ALLEGHENY COUNTY SANITARY AUTHORITY

CONTRACT NO. 1729 G, E, H, P

EAST HEADWORKS

ADDENDUM NO. 7

Contract: 1729
CAD File Name: 530-A-37.DGN
Date: OCTOBER 2020
Sheet: 102 of 645

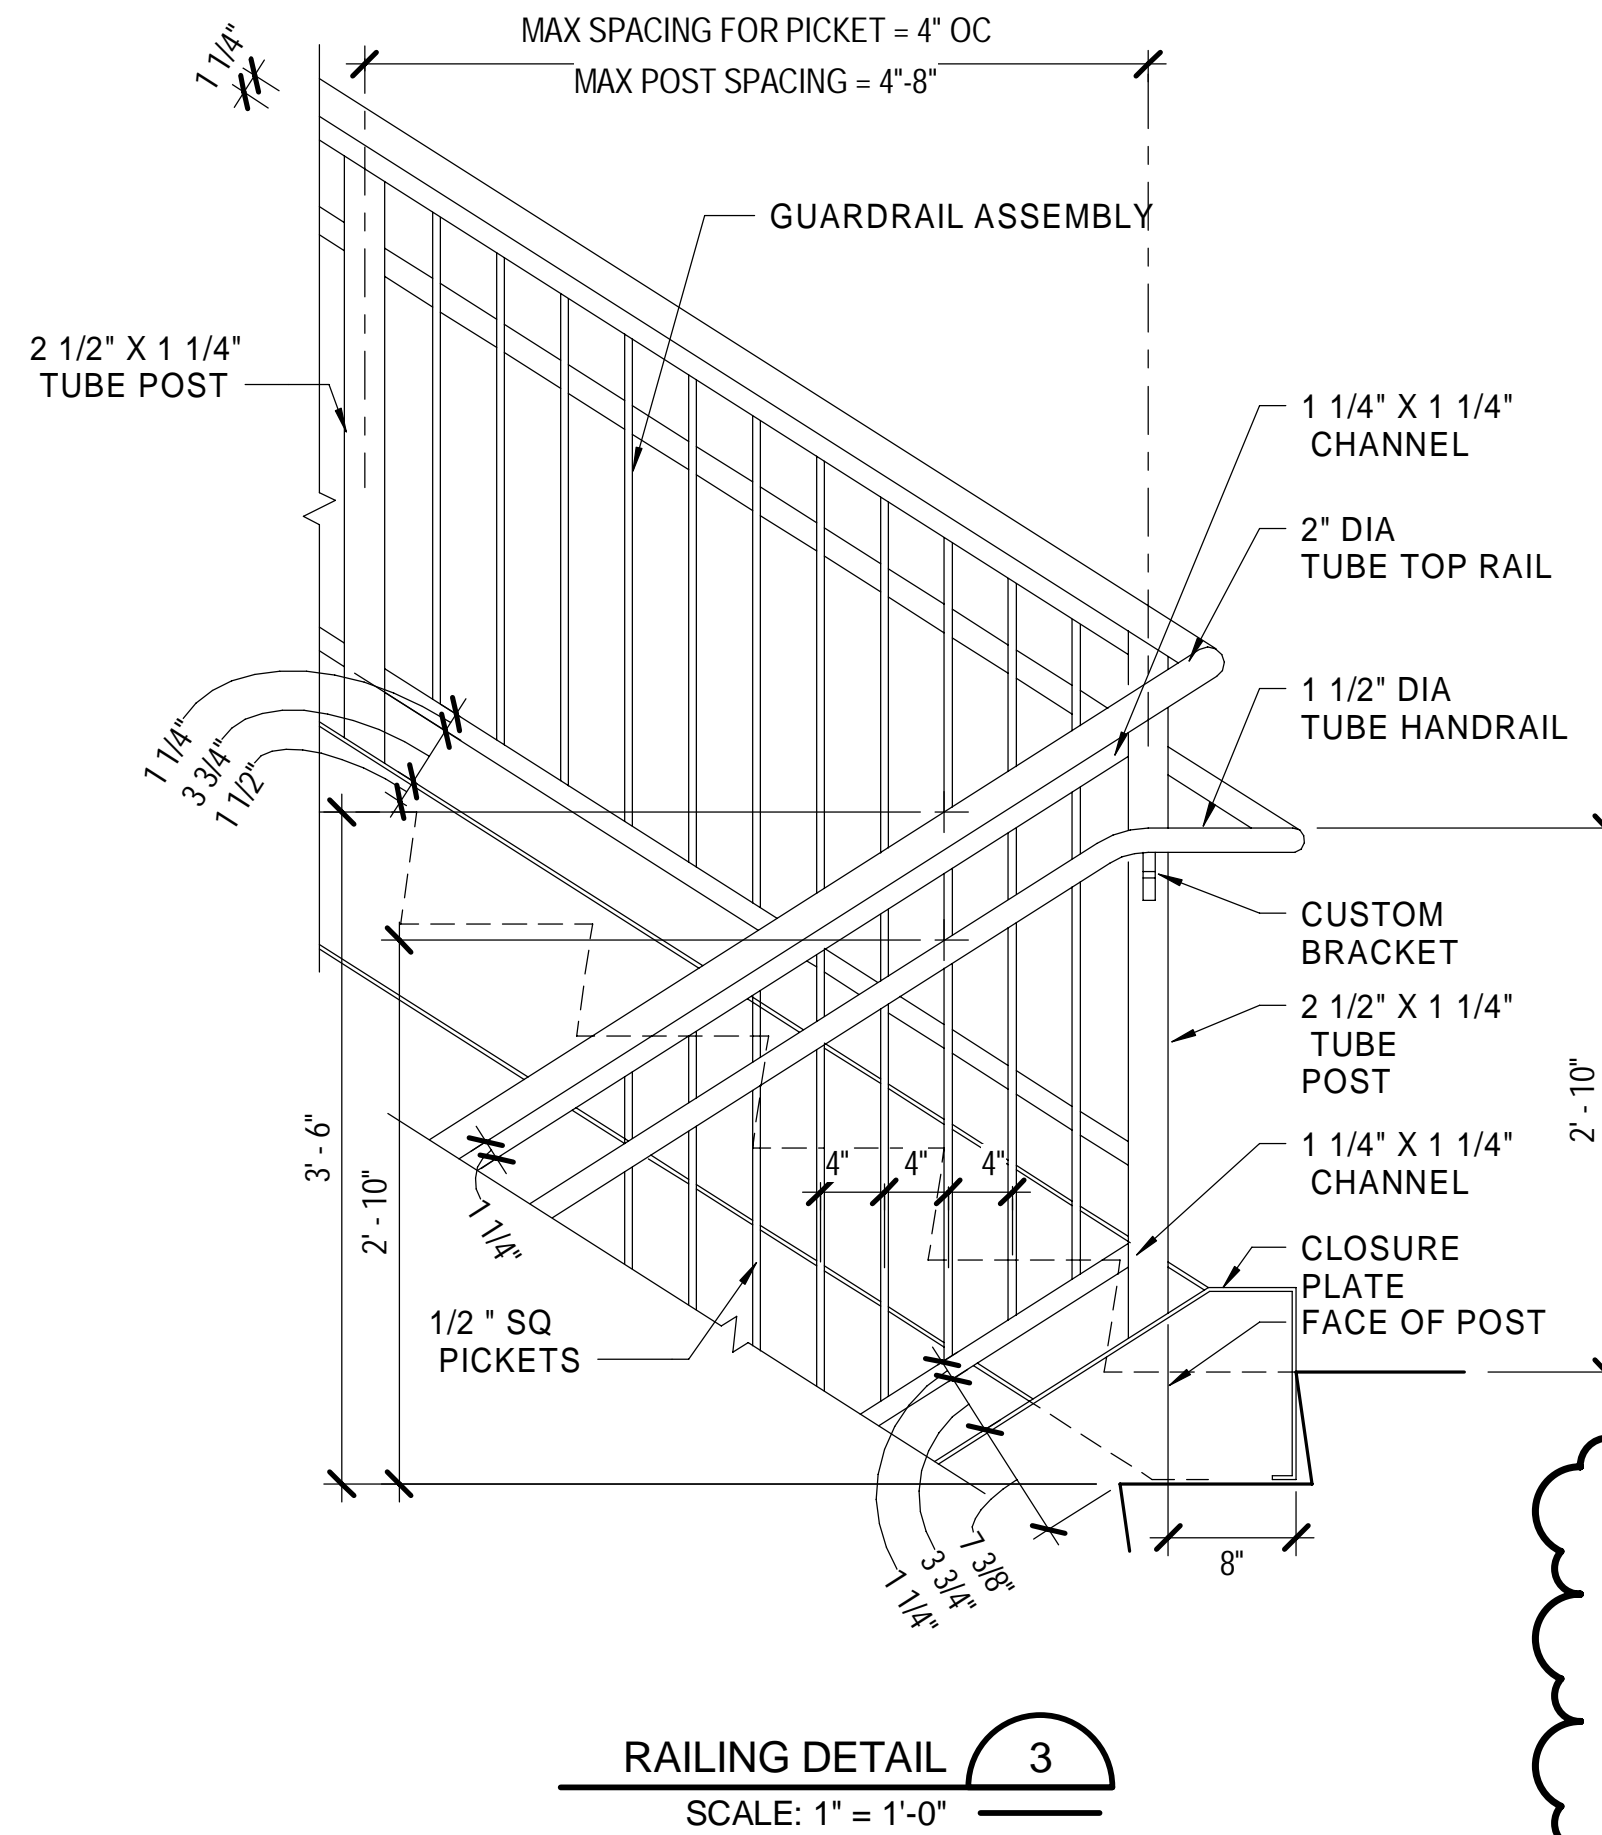
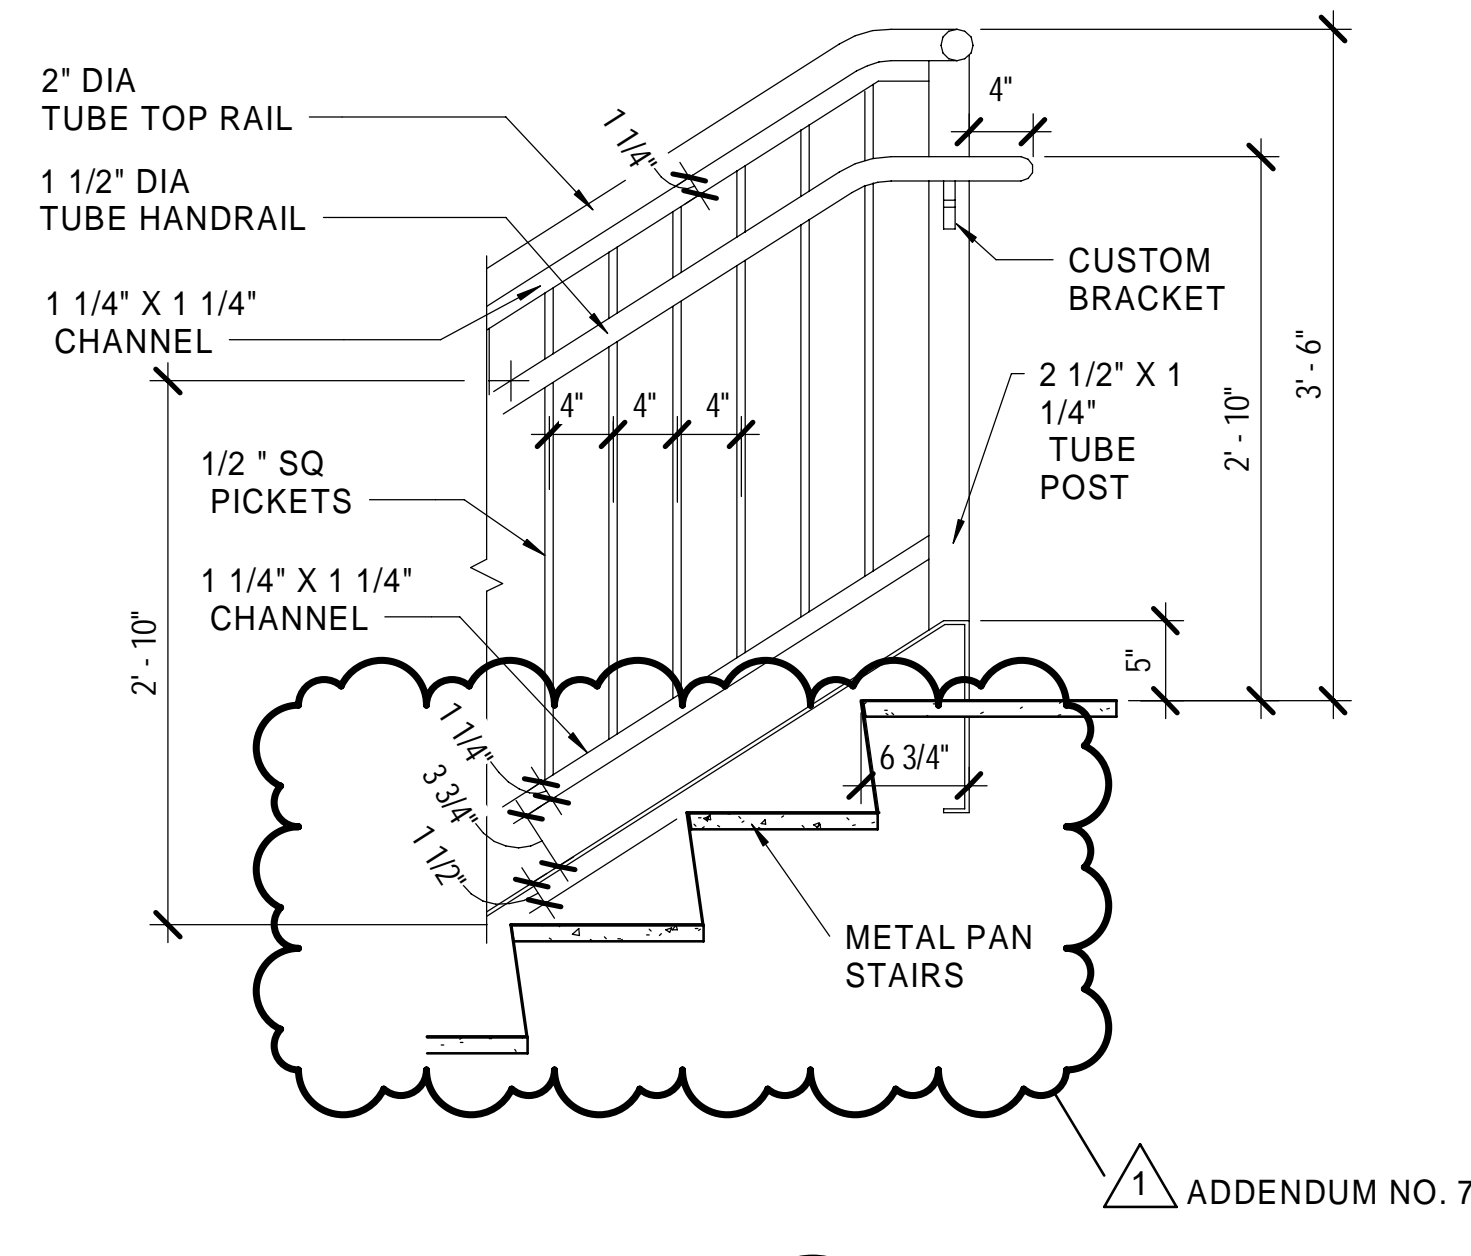
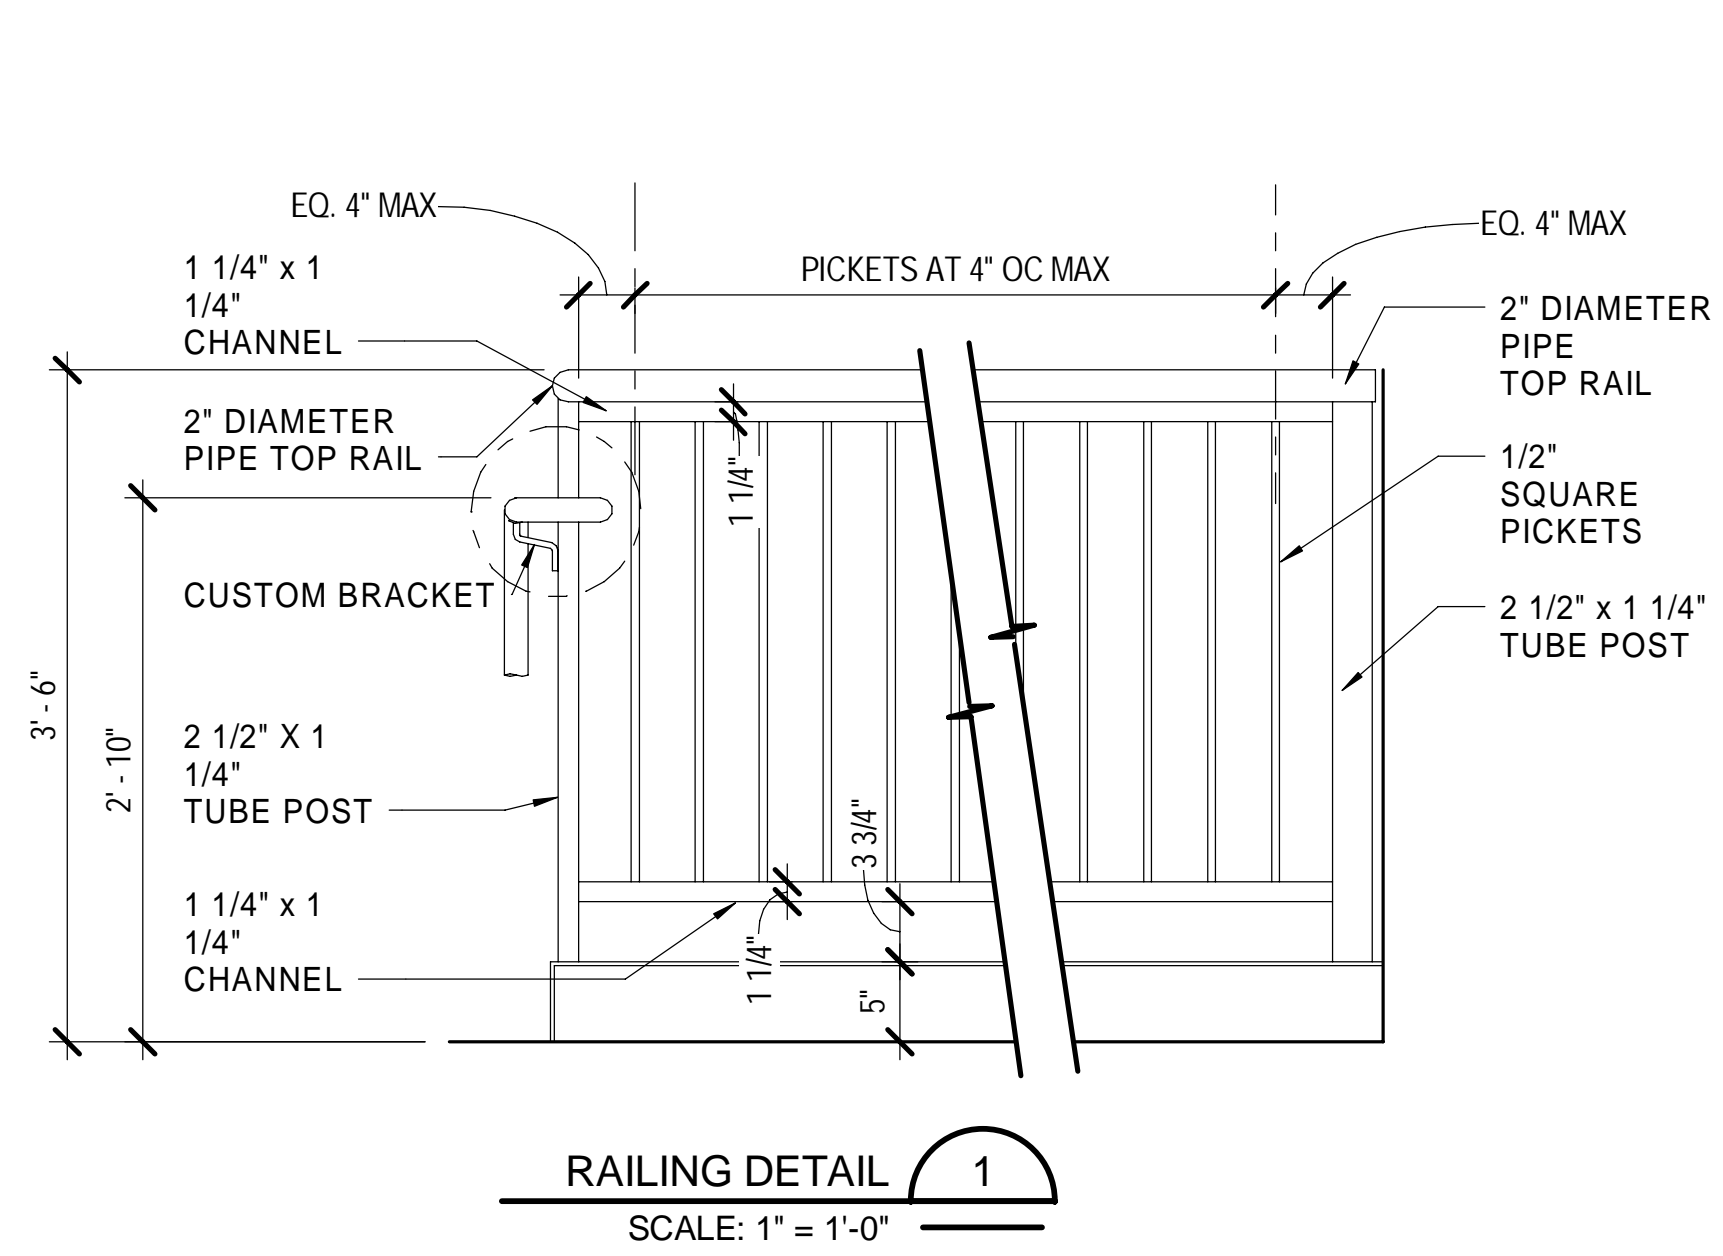
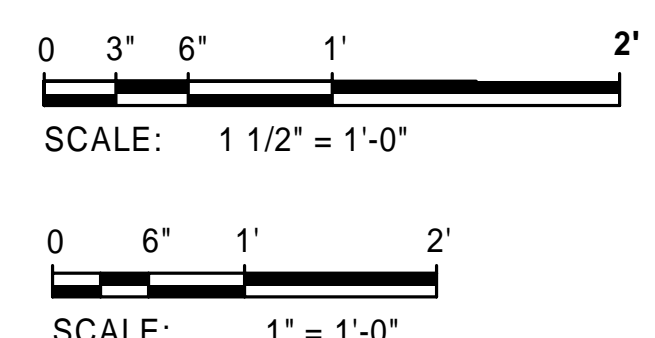
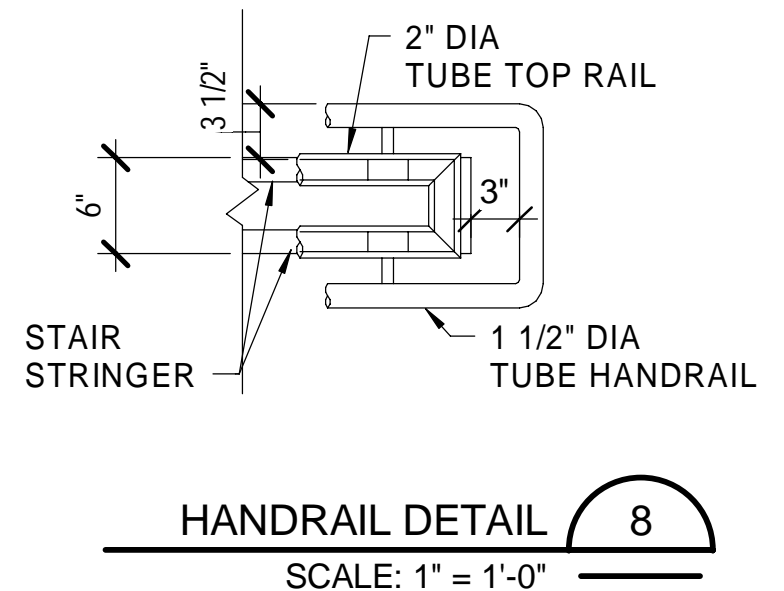
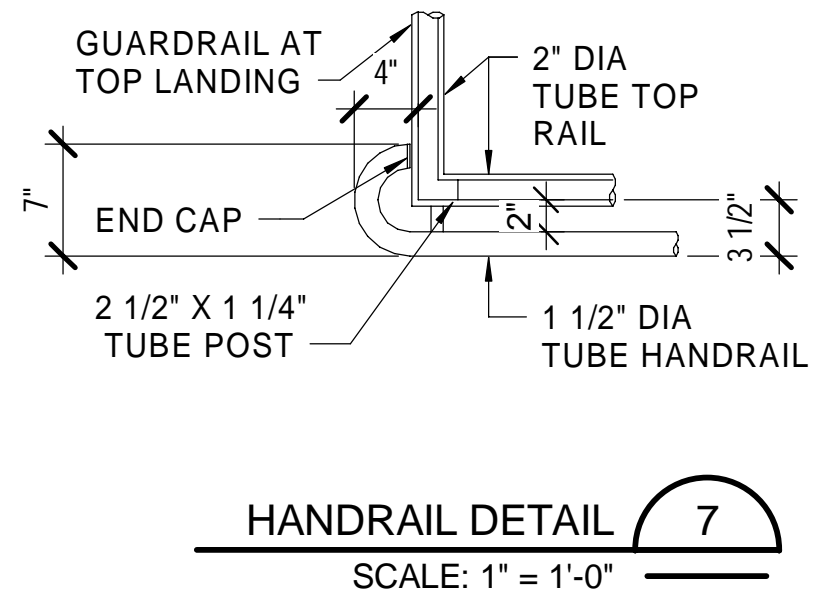
133. **QUESTION:** Reference drawing 530-A-37 (102 of 645), in section 1 for Stair 2 there are 2ea detail call outs numbered 1 and 3 from drawing 530-A-38 located near the top of the section view. On drawing 530-A-38 detail 1 and detail 3 are for railing details where there is not railing shown on 530-A-37. Also reference drawing 530-ELP-10 which shows the stairs extending to uppermost level of stair 2 as opposed to 530-A-37. It appears that drawing 530-A-37 may have been issued incorrectly and that the intent was to extend the stairs all the way to the top of the stairwell as indicated in 530-ELP-10. Please advise.

RESPONSE: The uppermost level of the stair was omitted from the drawing. The intent is for Stair 2 to terminate at the Penthouse Floor Level (Elevation 766). Refer to revised drawings 530-A-23, 530-A-28, and 530-A-36 through 39, issued with Addendum No. 7.
